Planning App Ref:	PL/2026/01153
Service Ref:	Drainage
Date:	19/03/2026

Discharge of conditions 7 (Lighting), 9 (SUDS), 10 (CEMP), 12 (LEMP), 13 (Contamination) and 16 (Archaeology) relating to application 20/00379/OUT following Appeal Ref: 3321957.

Land at Southwick Court Farm, South of Trowbridge

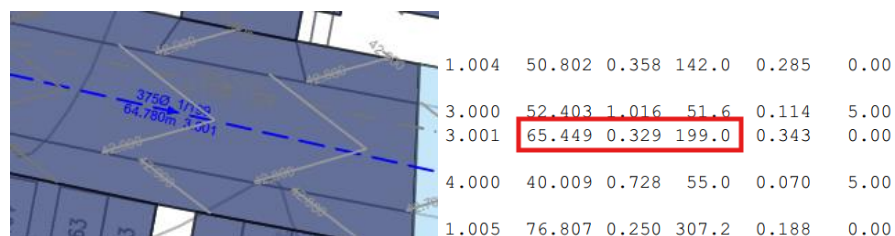
Although a Drainage Exceedance Plan has been submitted, further detail is required. The plan currently shows exceedance flow arrows along the highway and within individual plots but does not demonstrate how overland flows will be routed across the wider site. The applicant must show full exceedance pathways to evidence that potential impacts on adjacent people and property have been assessed and mitigated. In addition, no information has been provided on how exceedance flows from the rear of properties will be safely managed and directed to an appropriate location.

- It is noted the applicant has provided drainage exceedance plans, however further detail is required. Currently, exceedance flow arrows are provided along the highway and plots, however the applicant must demonstrate where flow will be directed across the extent of the site (e.g. green box).

This is required to demonstrate the applicant has considered how overland exceedance flows may impact adjacent people & property and mitigated any flood risk.

- The applicant must also outline how exceedance in rear properties will be safely managed and safely disposed of across the site (e.g. orange boxes).
